## Variance Request Form

### PG&E Hollister 115 kV Power Line Reconductoring Project

Variance Request No.: 12

Z:\Projects\PG&E\_Hollister\MXD\Attachment\_A\_Variance\_12\_Proposed\_New\_Access\_Road.mxd 2/3/2012

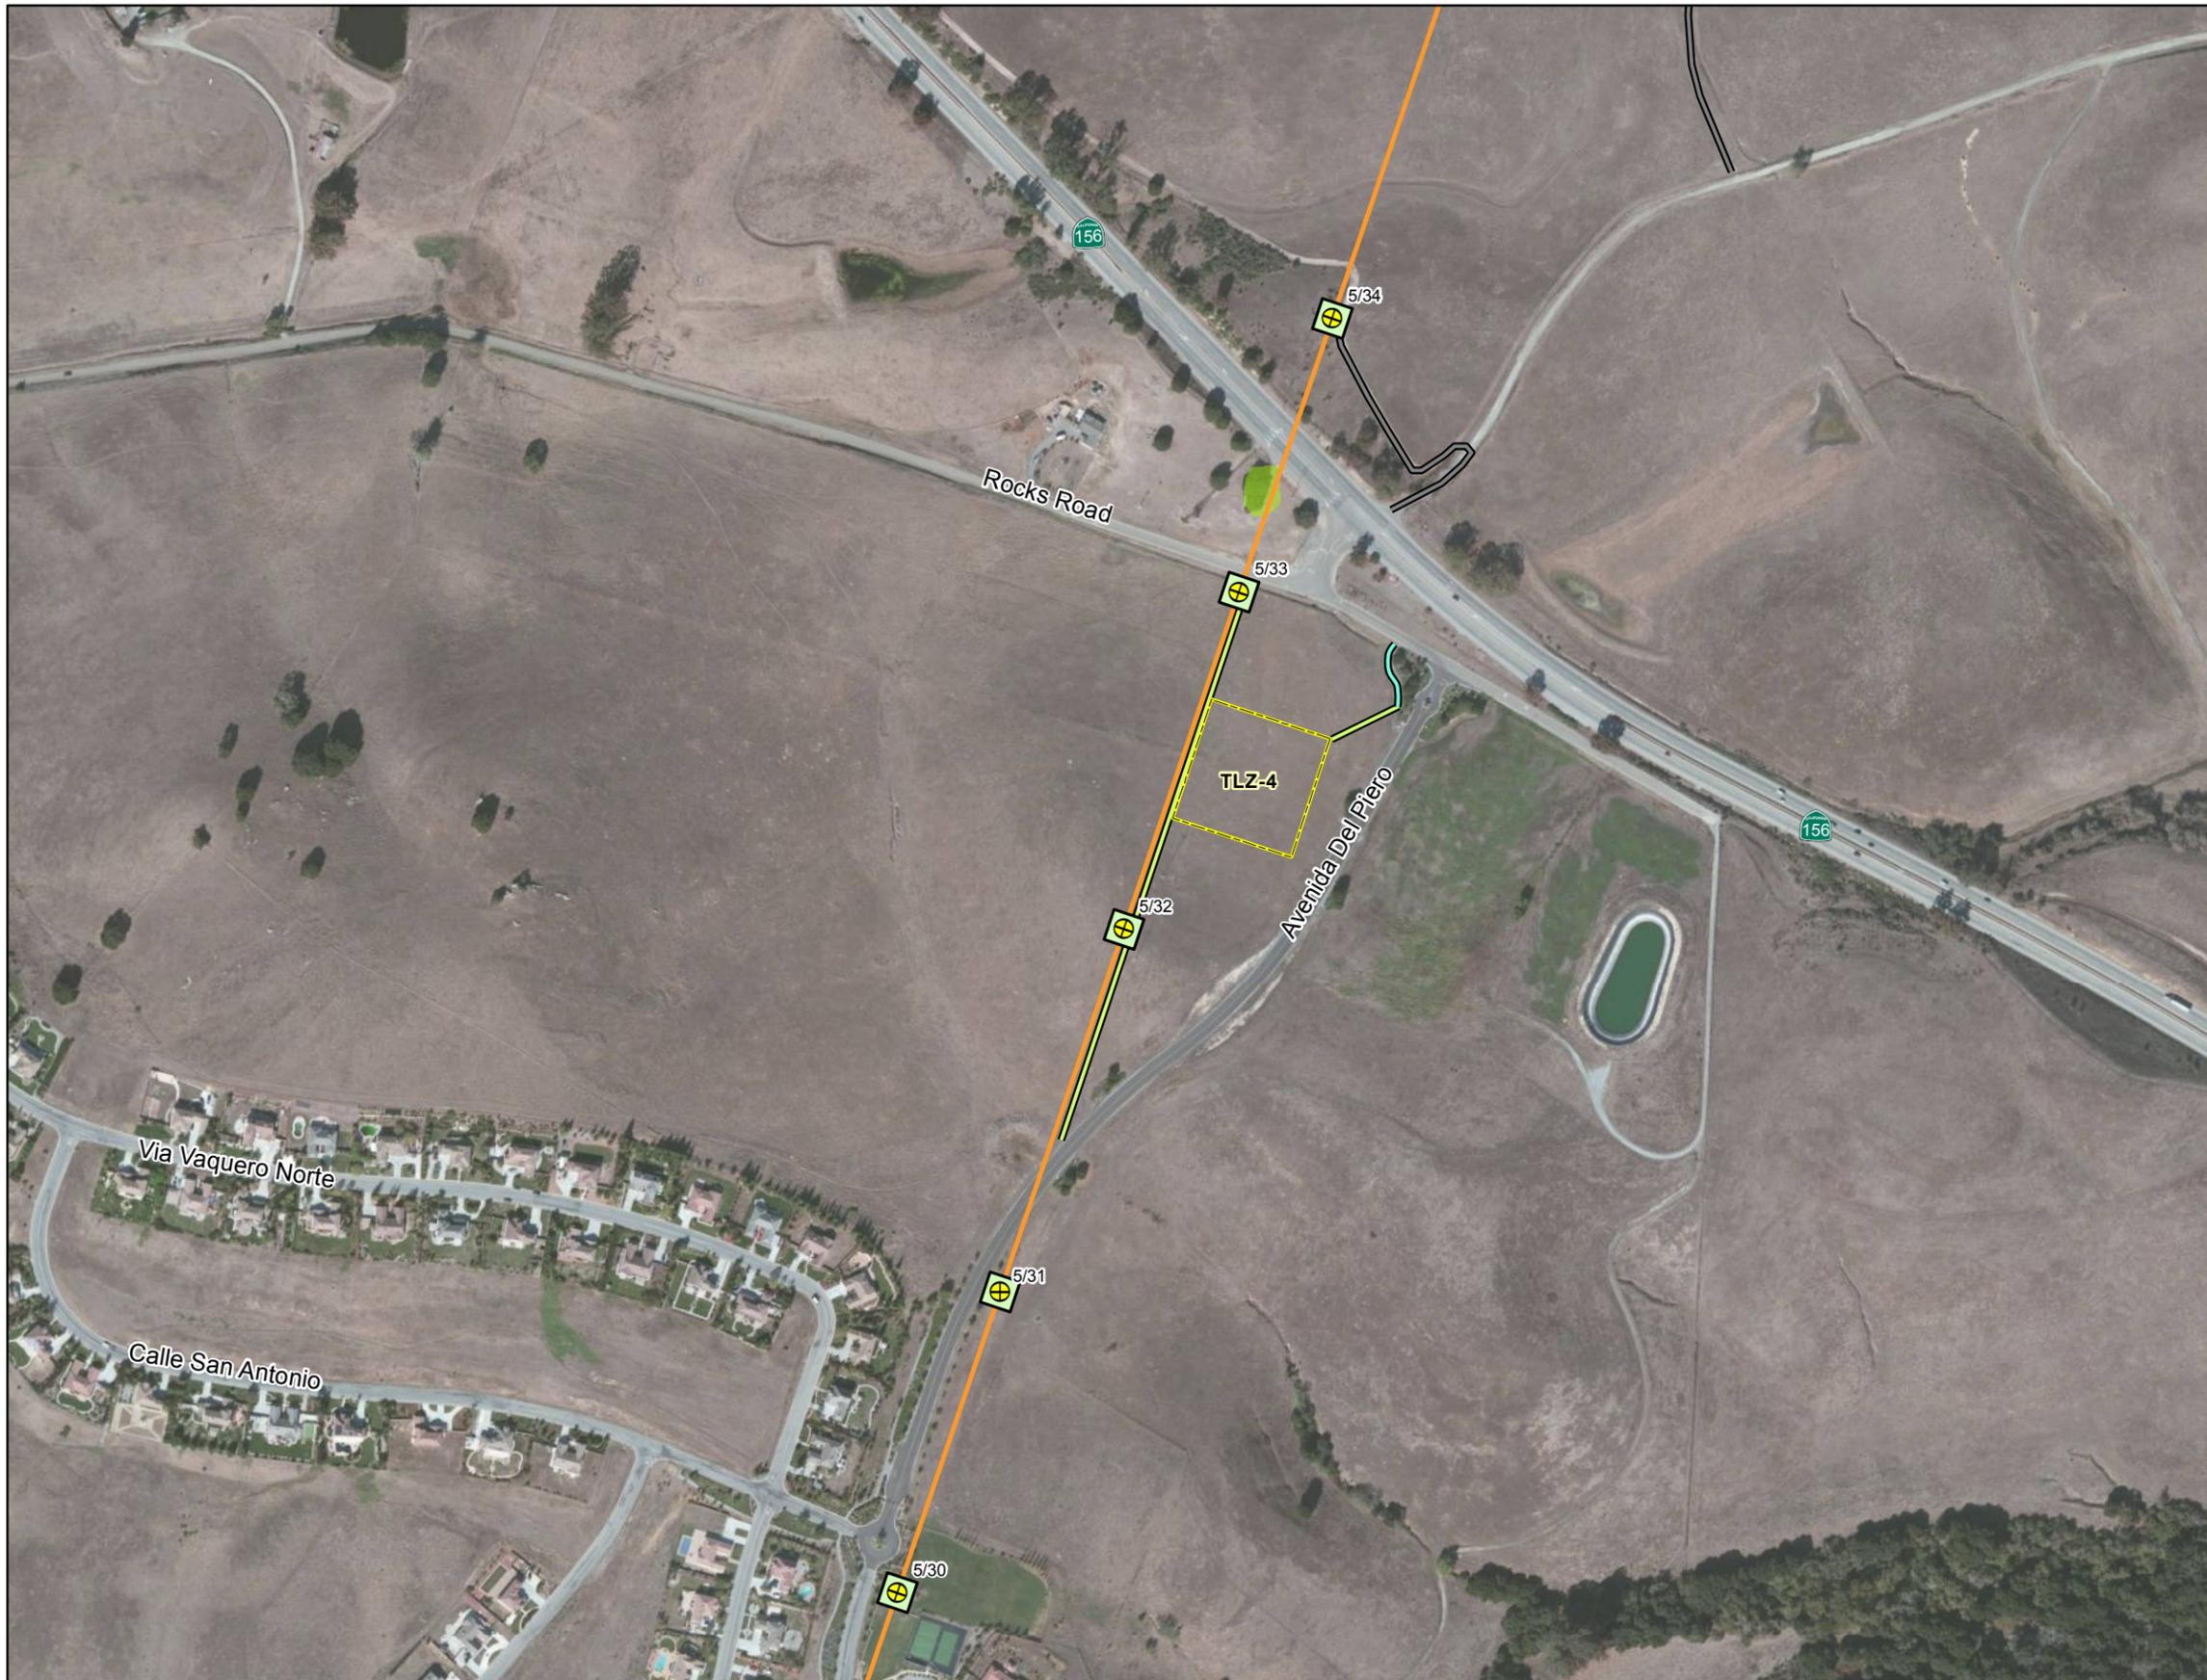
PG&E is requesting authorization from the CPUC to construct a new temporary access road (new access road) to TLZ-4 and allow for the installation of a geotextile and gravel surface at TLZ-4 and along the new access road. A new access road location has been identified by PG&E that will provide a more direct route to TLZ-4, avoid a roadside drainage along Avenida Del Piero, and provide a more stable road surface during the rainy season, compared to the previously-approved overland travel route along the power line ROW. The new access road was not originally proposed in the MND, but is within the 500-foot survey buffer for biological and cultural resources. In addition, PG&E has identified the need to stabilize nearly the entire 2.0-acre work area at TLZ-4 and the new access road with multiple layers of geotextile fabric and base rock or wash gravel (gravel). Stabilizing the area is anticipated to provide a more secure surface for heavy equipment at this site. All geotextile and gravel surfaces will be temporary and removed at the end of the project. This variance request consists of the following components:

- Construction of a new 15-foot-wide access road along approximately 160 feet of an existing road, which will consist of multiple layers of geotextile fabric and gravel;
- Continuation of the new 15-foot-wide access road overland across approximately 180 feet of both non-native grassland and agricultural land, which will consist of multiple layers of geotextile fabric and gravel; and
- Installation of multiple layers of geotextile fabric and gravel at the 2.0 acre work area at TLZ-4.

The new access road will be approximately 340 feet long and 15 feet wide (0.12 acre) and will run from a location approximately 100 feet west of the intersection of Avenida Del Piero and Rocks Road approximately southwest to the eastern boundary of TLZ-4. Consistent with the project description in the MND, the new access road may reach a maximum of 30 feet wide at corners, to allow adequate room for trucks to navigate the road. From Rocks Road, the new access road will cross over an existing culvert and follow an existing road for approximately 160 feet. The new access road will then traverse overland an area of maintained non-native grassland and an area of agricultural land, currently being used for cattle grazing, for approximately 180 feet. A temporary gate will be installed where the access road crosses an existing cattle fence. The new access road will not be graded or cleared of vegetation; however, multiple layers of geotextile fabric and gravel surface will be installed along the new access road to protect the soil from compaction and/or rutting resulting from the use of the road by construction vehicles, and to reduce the potential for construction vehicles to track sediment off-site and onto public roads. Approximately 115 cubic yards of gravel with an average depth of six inches will be placed on top of the multiple layers of geotextile fabric. In addition, a 3-inch by 2-inch gravel base and rumble plate will be installed at the entrance of the new access road from Rocks Road. If necessary, steel plates will be placed over the culvert crossing to prevent damage to the culvert from heavy construction equipment. Following construction of the project, the multiple layers of geotextile fabric, gravel, the 3-inch by 2-inch gravel base, rumble plate, and steel plates, if necessary, will be removed to allow the disturbed areas to revegetate naturally.

The location of the new access road to TLZ-4 is provided in Attachment A: Variance #12 Location Map. Photographs of the new access road and TLZ-4 are provided in Attachment B: Photographs.
